SYKES/LESLIE RESIDENCES

5616 Westport Pl, West Vancouver, BC

OCTOBER, 2015 (RE-PRINTED APRIL 2016)

DESIGN REVIEW COMMITTEE DESIGN CHANGES

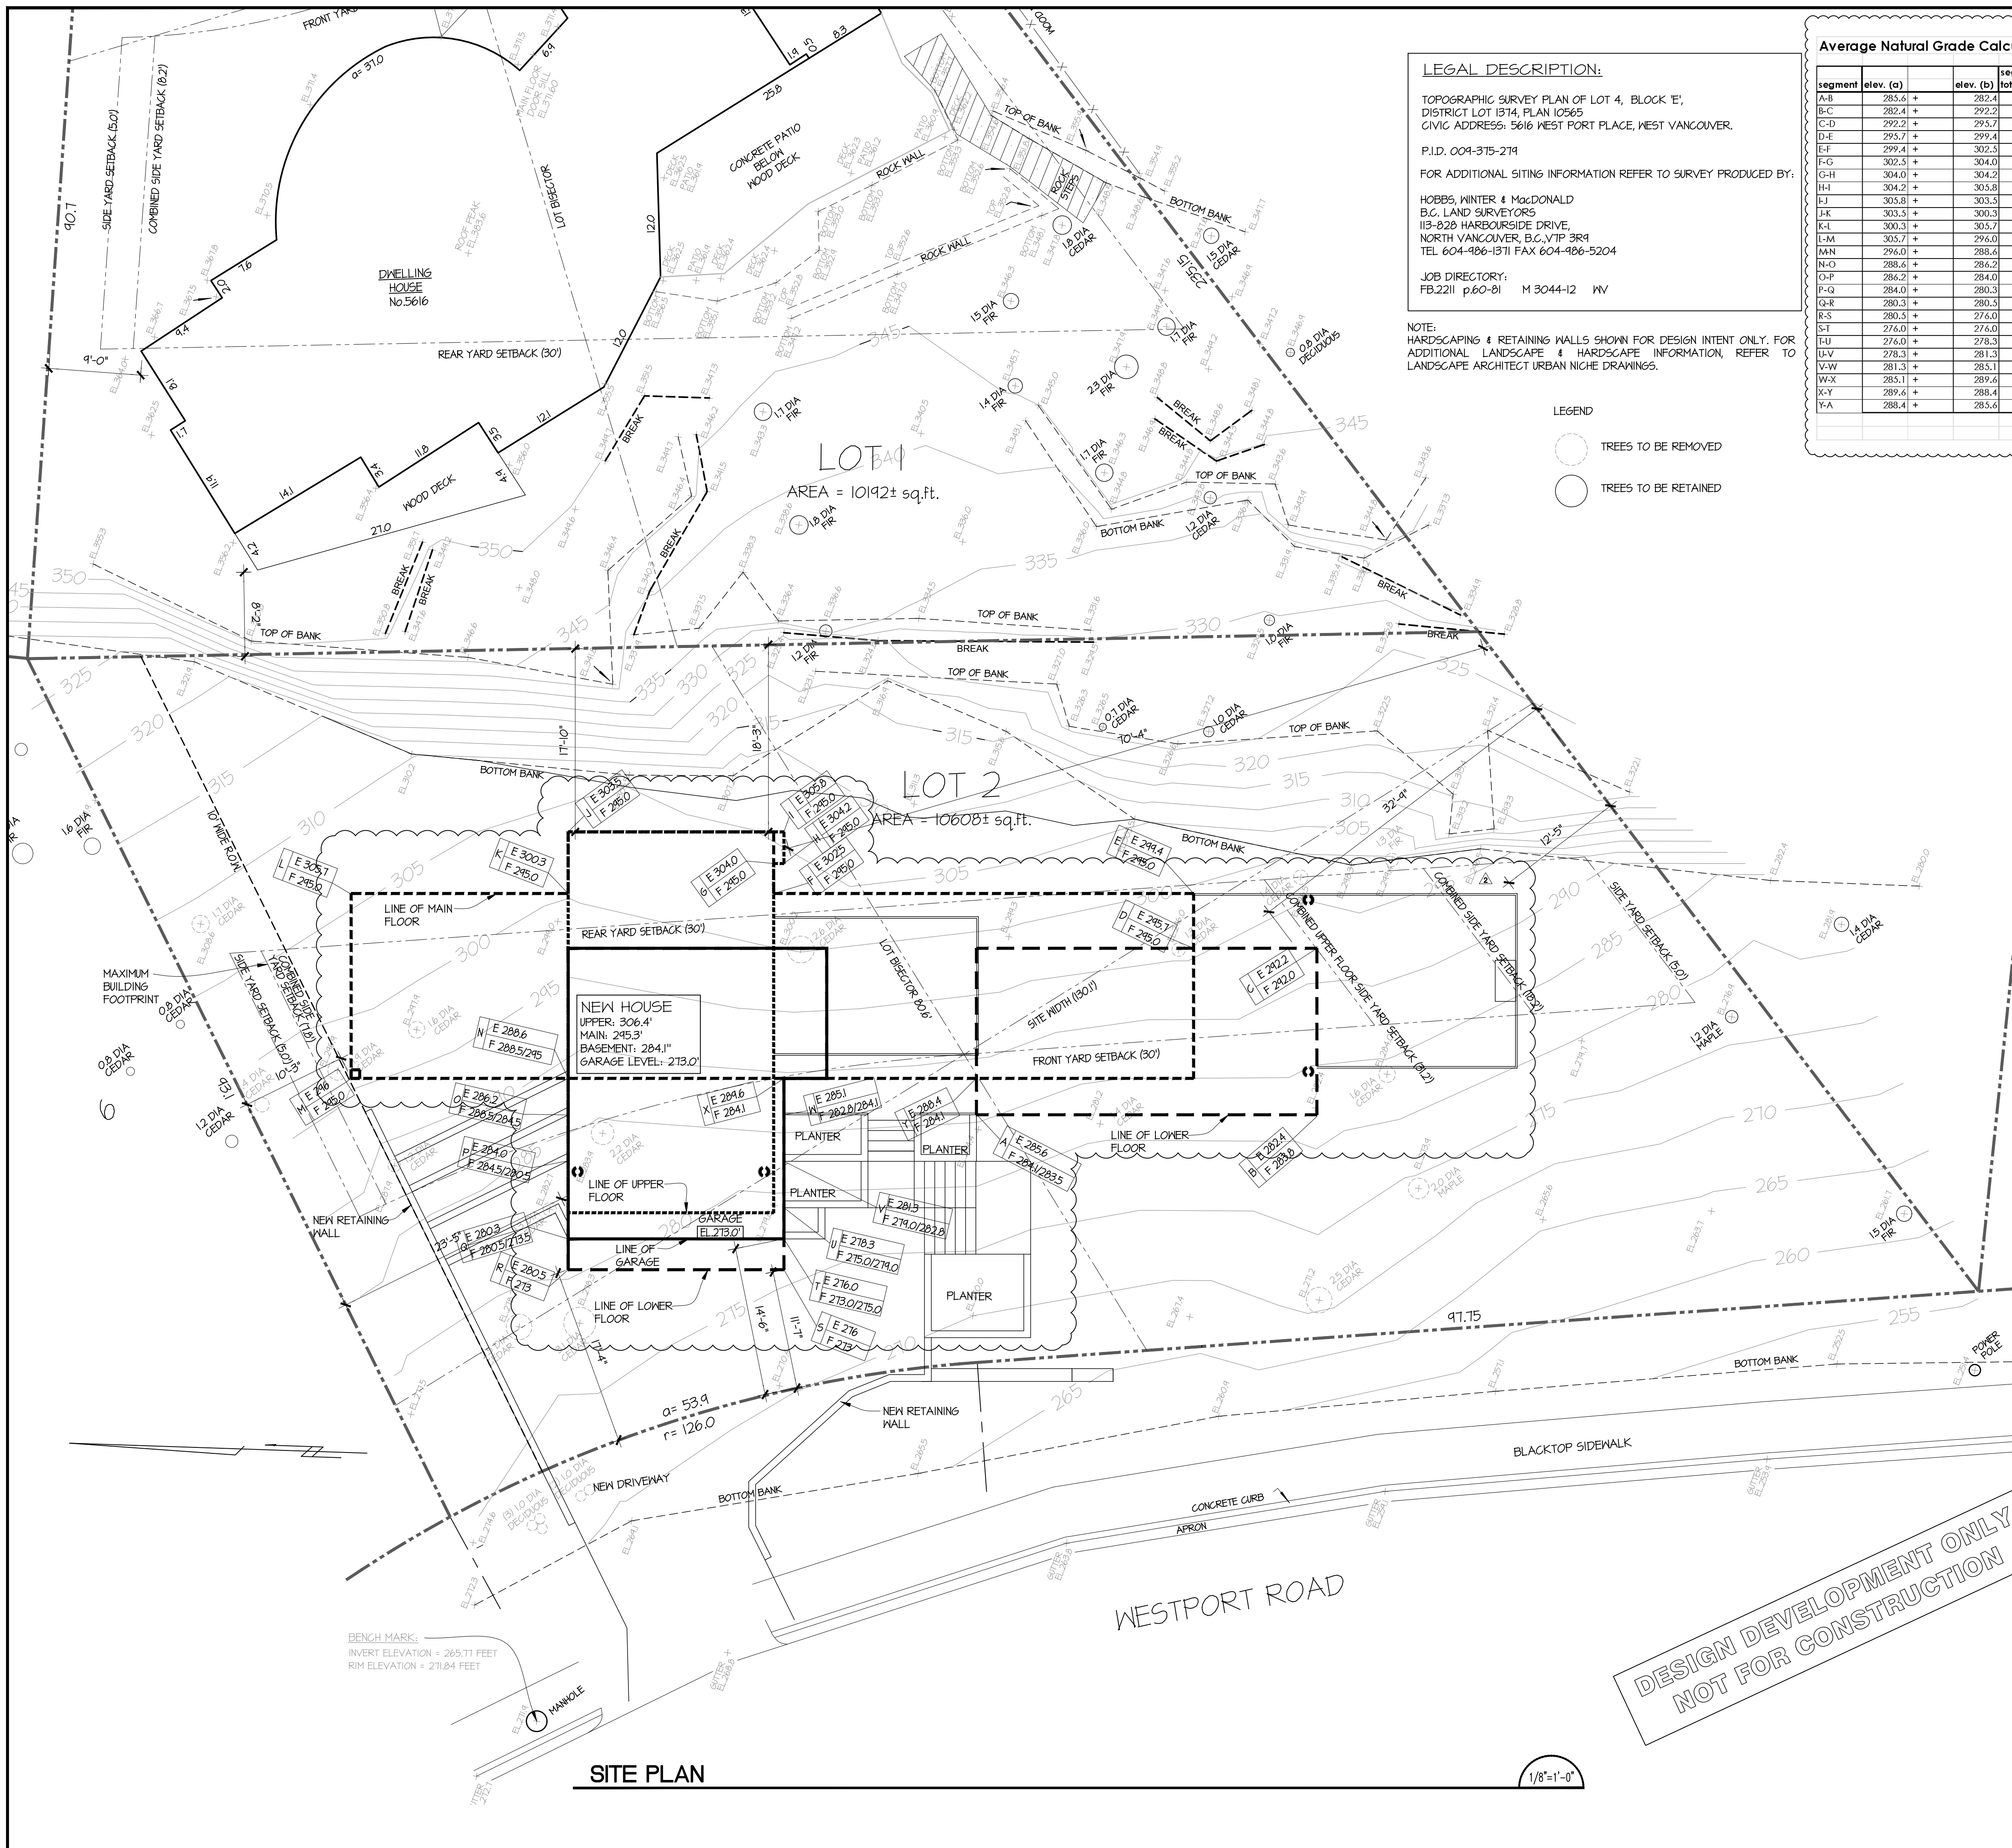
1. Reduce floor to ceiling heights

a. Garage	14'-2" to 10'-0"	4'-2" reduction
b. Lower	13'-0" to 10'-0"	3'-0" reduction
c. Main	10'-0" to 10'-0"	no reduction
d. Up	10'-0" to 9'-0"	1'-0" reduction

e. Total Reduction:		8'-2" reduction
2. Garage Floor:
 - a. Eliminate 6 or 7 risers at west side of elevator
 - b. Move garage back 3'-0" +/- . Garage setback from 11'-6" to 14'-6" (4.42m)

3. Lower Floor:
 - a. Eliminate 6 or 7 risers at west side of elevator
 - b. Reduce depth of relax space by 6'-0" +/- (maintain 3'-0" overhang on garage and increases setback from 6'-0" to 11'-7" (3.5m)

4. Living Floor:
 - a. Reduce length of side deck by 6'-6"
 - b. Side setback to be increased to 12'-5"
5. Upper Floor: No changes
6. Landscape:
 - a. Propose keeping 1 tree at the side of the deck and 2 trees behind the deck - Arborist report does show they are in very poor condition.

- b. Graphically show a more natural and less regimented landscape pattern
